**Subject:** Check of control circuit clearance inside the fuselage tail boom to fin intersection.

**Serial number applicability:** All ASW 27, Document No. 04 - 389, Serial Numbers 27002 through 27 104 .

**Fig. 1A**

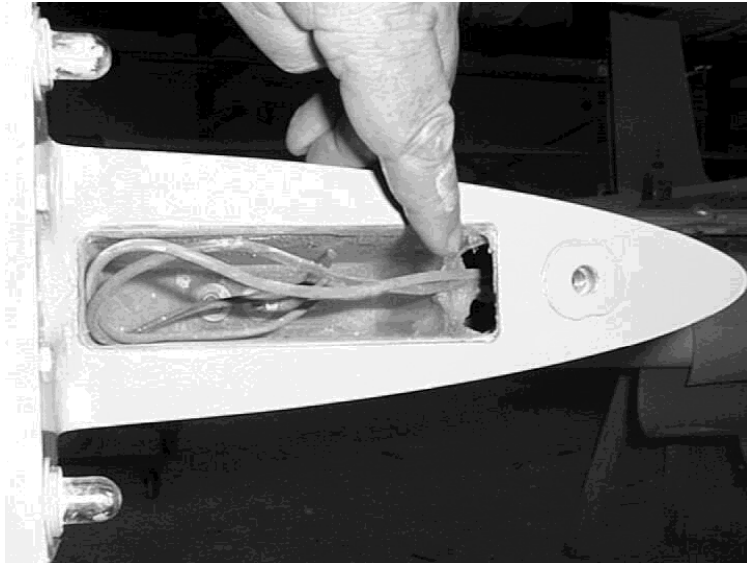
**Action:** **1)** De-rig the horizontal tailplane, look through fin ballast box as shown in Fig. 1A and check the clearance left and right of the mass balance weights, see Fig. 1B. A strong light which is held to the outside of the fuselage to fin intersection close to the critical area improves the visibility remarkably.  
**NOTE:** The critical situation is reached, when the elevator actuator is fully down. When the clearance (including bolt head and nut or bolt end) is about symmetric and 2,5 mm (1/10 inch) wide, no further action is needed.

**Fig. 2**

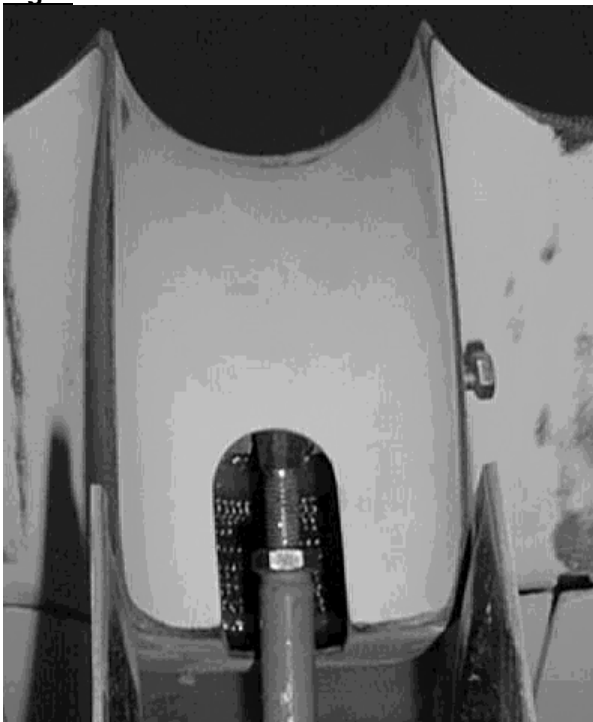
**2)** When the clearance is insufficient, the situation can be remarkably improved by rotating the 90° lever forward and downward. To accomplish that, the bolt at the elevator actuator must be removed and the universal joint must be turned into the push rod so that it gets shorter, see Fig. 2. To compensate the adjustment in length, the push rod at the left hand side of the cockpit must also be shortened by the same number of threads. To get to the push rod the cockpit seat pan must be removed, see Fig. 3. When the threads at the cockpit push rod are not sufficient to get enough clearance at the lever, the front push rod may be shortened by an authorised welder for aircraft components.

**Fig. 3**

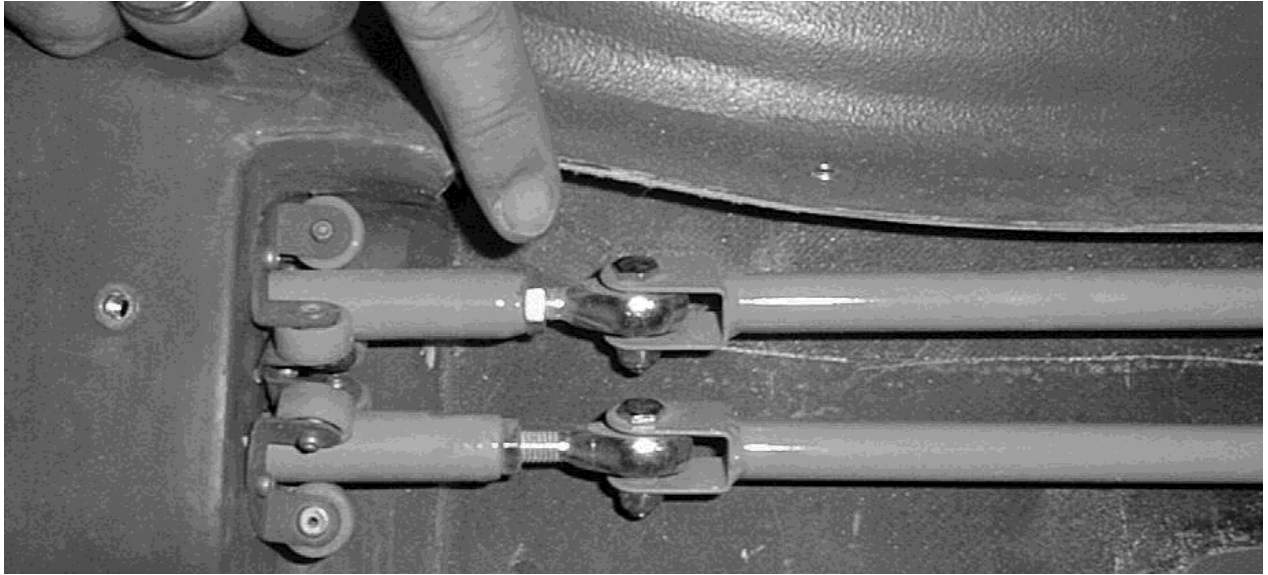
**3)** When action according to 2) was necessary, the elevator deflections must be checked and be adjusted within the tolerances given in the Maintenance Manual, page 3.2. Now the adjusted control components must be safetied and checked (see also the other problem areas marked in Fig. 3 and 4 and reinstall the seat pan.
